ECR/Documents for Information and Approval

Giulia Romagnoli and Natalya Kahn for BE-EA, 2024-12-17

SPSX-SF-EC-0016

AUG installation EHN2+ AUL removal EHN1, GIF++/H8 and EHN2/M2/BA82

Figure 3: AUL removal and AUG installation in EHN2 (ground floor) [3].

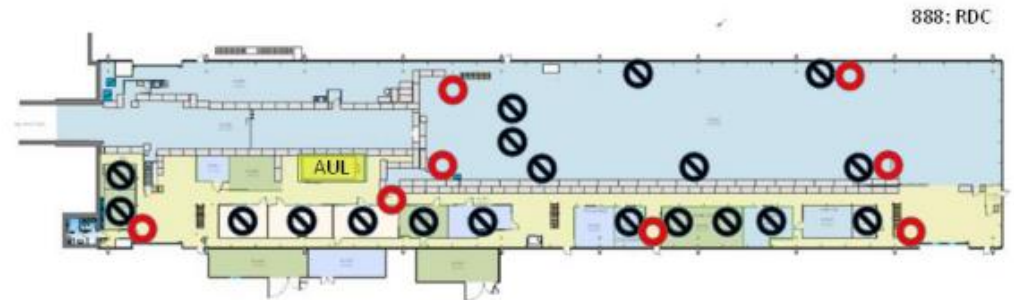
One AUL will remain in operation in EHN2 zone R-0009, however the NANO PLC system will be removed entirely. How will this impact the functioning of the remaining AUL ?

Concerning the EIS system no details are required.
With reference to Yacine's comment the remaining AUL will be directly wired to corresponding breaker or we will provide AUL interface in case it has to actuate more than one breaker.

Figure 4: Modifications needed in the shielding bridge area.

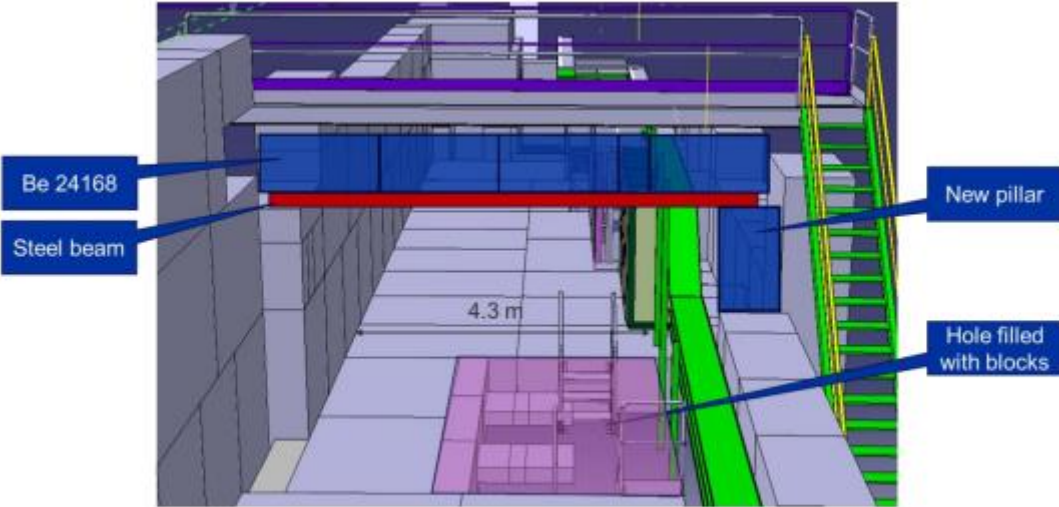
⚠ **Accepted with Warning** by **MORTON Richard Francis** (HSE-OHS) Created on 2024-09-03, 14:57
The structural aspect of the concrete blocks must be assessed, HSE can assist with the seismic checks and advise on effects of the new arrangement on the existing structures.

➡ **Seen** by **KADI Yacine** (BE-EA) Created on 2024-09-03, 18:00
the proposed wall to be installed upstream of the bridge should be validated against seismic risks. Not sure the results would come before YETS 24/25 which is foreseen for these modifications.
In several occasions, one is referring to shielding improvements but there is no reference to any shielding calculations having been performed ?

- ✔ **Accepted** by PIRA Yann Pierre (HSE-RP) Created on 2024-09-10
OK
- ⚠ **Accepted with Warning** by BERTONE Caterina (EN-HE) Created on 2024-10-03
First of all, please don't forget to consult me for each ECR circulating in this area or wherever else at CERN!
Have the structural resistance of the red beams been verified ? in particular for the addition of extra vertical shielding.
Please ask to M. Andreini a seismic verification as he proposes.
Has the crane passage after addition of extra shielding been verified?

- ✔ **Accepted** by ROMAGNOLI Giulia (BE-EA) Last modified on 2024-12-17, 11:15 | Created on 2024-12-17
Seismic calculations done by HSE-OHS and SCE/SAM. Report available in [EDMS 3212641](#).
To reply to Caterina, in a first moment the additional shielding will not be installed, so the crane passage is guaranteed.
